PlanGrid Task Report - Oct 14, 2024

L04730_Homestead FSU (FL)

L1020004730

Sheet
M-301

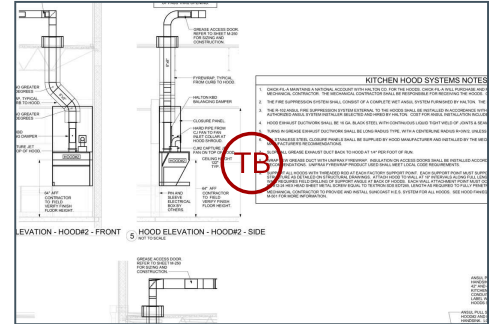
Grease duct is not wrapped with UNIFRAX FYREWRAP as per mechanical plans.

Sheet
M-201

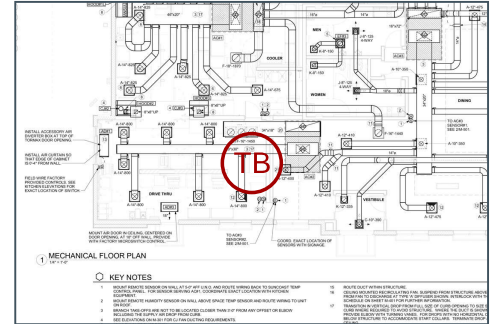
RTU 2 Diffuser 4 damper is rattling and moving around. The diffuser has been set to design and handle locked down, but the damper shaft & blade continue to oscillate. Damper will need to be serviced or replaced. Recommend setting damper to full open once resolved.

Sheet
M-201

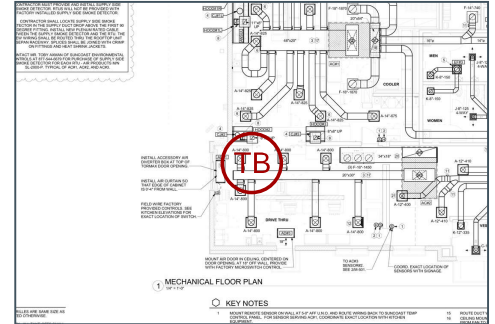
RTU 2 Diffuser 7 is outputting design airflow but making a noticeable rattling noise. Damper is adjusted to design and locked down, there is no movement on the damper shaft. Recommend MC investigate inside of ductwork to resolve the noise, without adjusting the damper.

Sheet
M-201

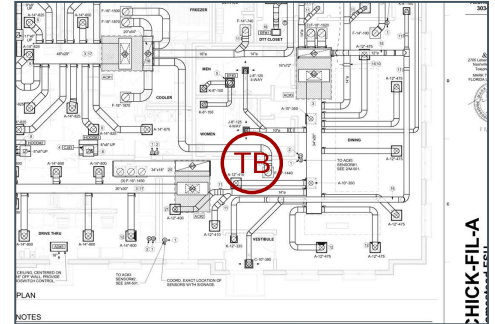
Description
Return damper is bound in partially closed position. This will need to be freed and opened.

Sheet
M-201

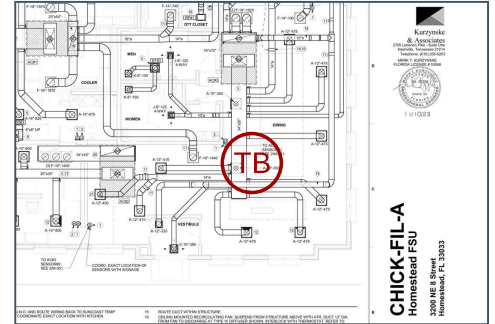
Description
SGRD3-5 Damper handle is missing hardware to lock the damper position in place.

Sheet
M-901

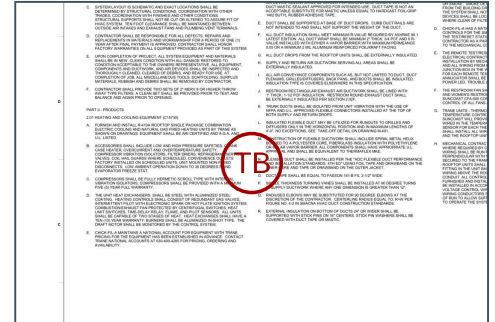
Ensure flex inner core is taped and banded, along with tape or banding on outer insulation jacket. Inner cores are not taped, only banded.

Sheet
M-401

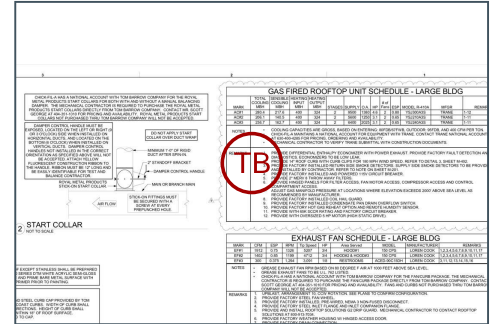
The mechanical plans call for standard 14" curbs to be used. Instead plenum curbs have been installed. If the units can be reset (and resealed) to resolve the leakage issues, CFA and the ME will need to approve this change.

20241002_134548_photo

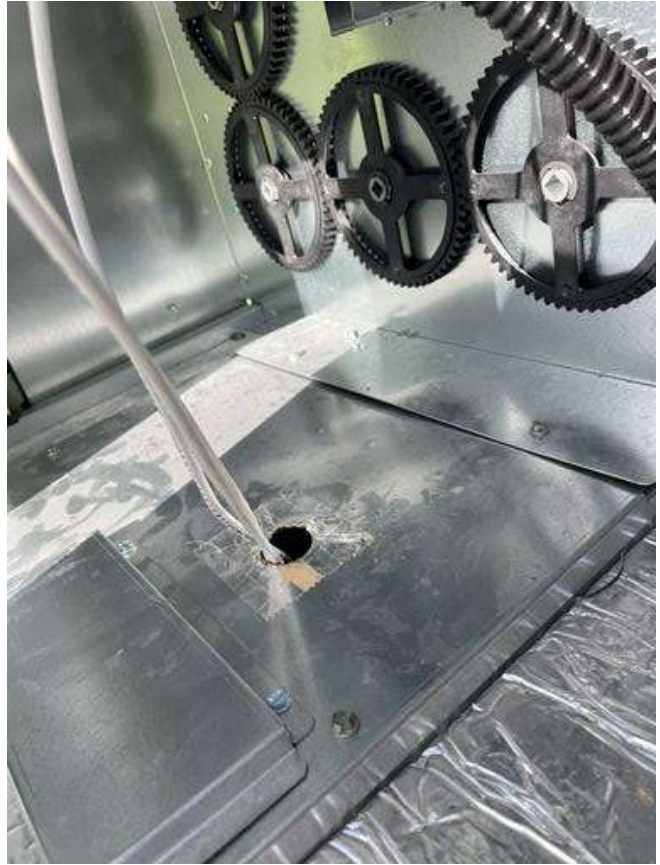
The low voltage wires are ran through the return drops. It is not recommended to run any wires through any of the ductwork.

Wires removed. Ensure all previously drilled holes are permanently sealed.
